CITY OF SAN ANTONIO

Re: Talley Road 233 (Amendment) MDP # 743A

The City Staff Development Review Committee has reviewed Talley Road 233 Master Development Plan M.D.P. # 743A (Amendment). Please find enclosed a signed copy for your files. Your plan was accepted, however please note the following:

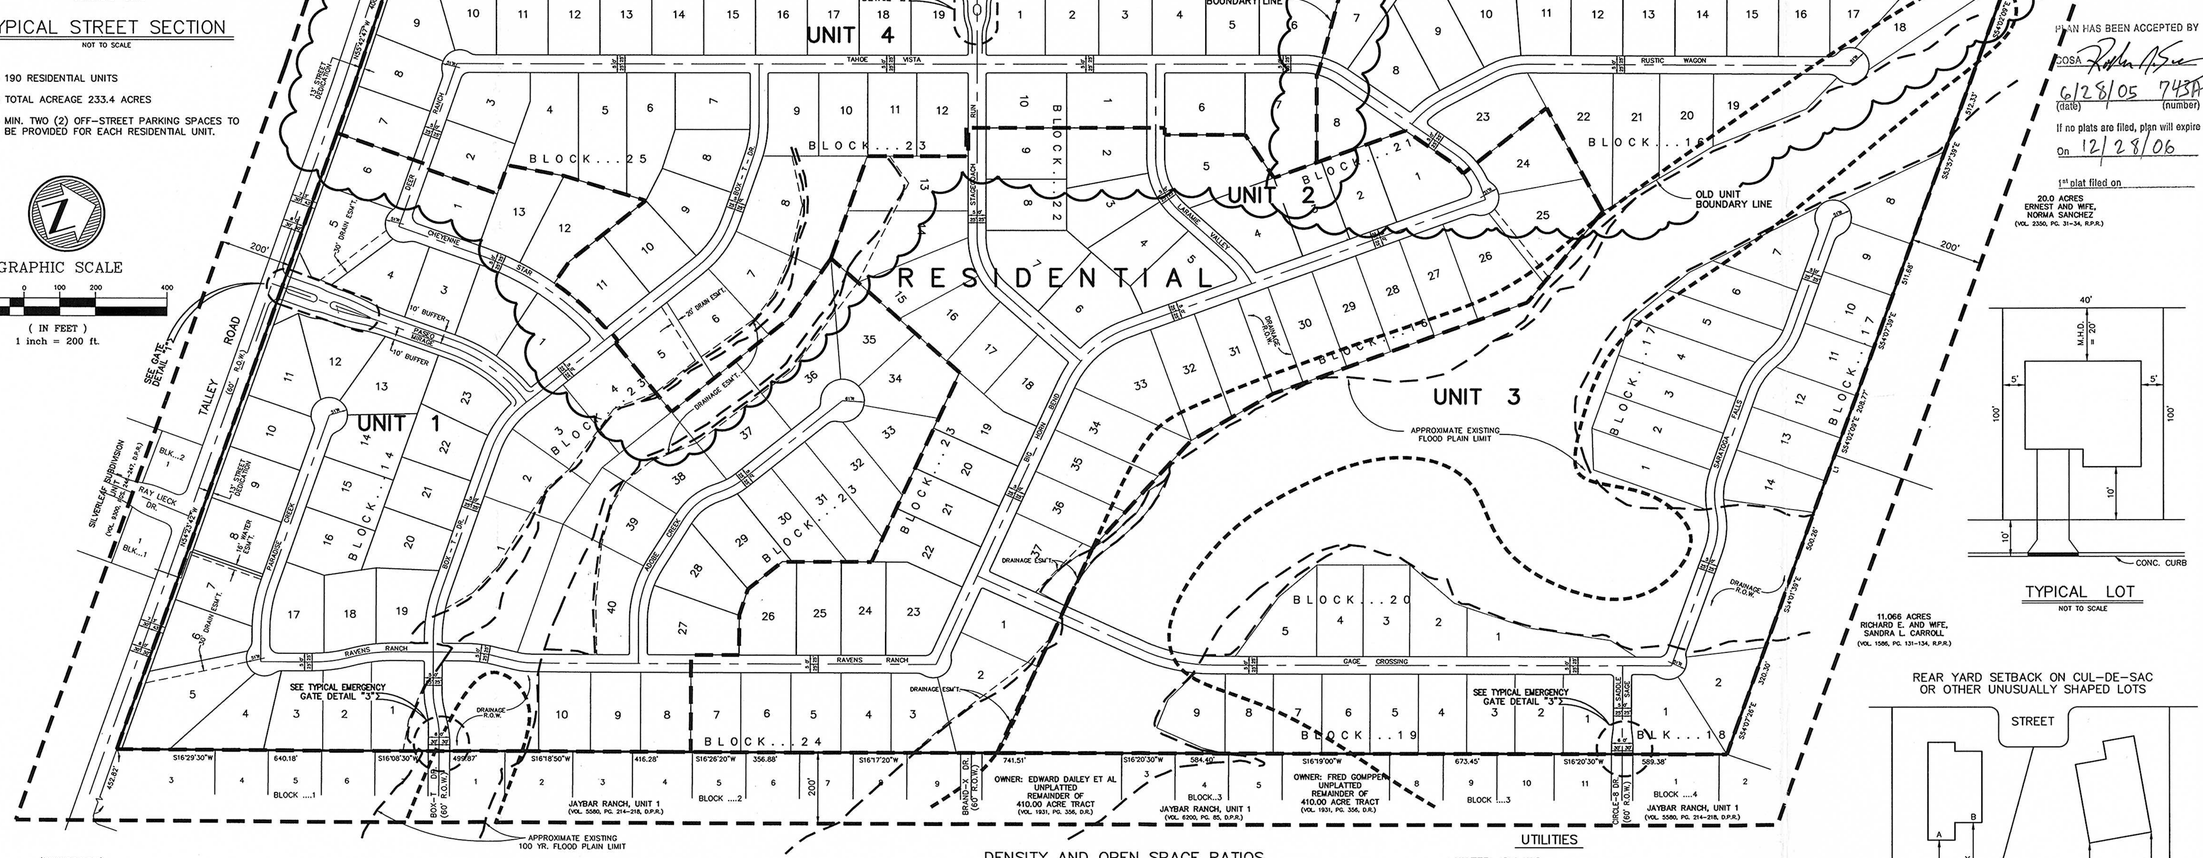
a.) At the completion of the first unit for this development, the Developer shall provide 60 feet of ROW and construct half of the Primary Arterial Type "A" for the North – South connection adjacent to the west side of the proposed development. The length just described is approximately 4600 linear feet. This will require a property dedication by the developer.

b.) The above requirement was not adhered to during the platting stage of this particular MDP. A note has been placed on the MDP amendment #743A to rectify the need for secondary access as per UDC 35-506 (e) (7). The remaining phases shall comply with the clouded notes placed on the amended Master Development Plan, MDP #743A.

NOTES:
1. UNIT 4 SHALL BE CONSTRUCTED BEFORE UNIT 3.
2. PHASE "A" OF THE NORTH-SOUTH CONNECTION TO BE CONSTRUCTED WITH UNIT 4. PHASE "B" TO BE CONSTRUCTED WITH UNIT 3. DEVELOPER RESERVES THE RIGHT TO BUILD BOTH PHASE "A" & "B" WITH UNIT 4.
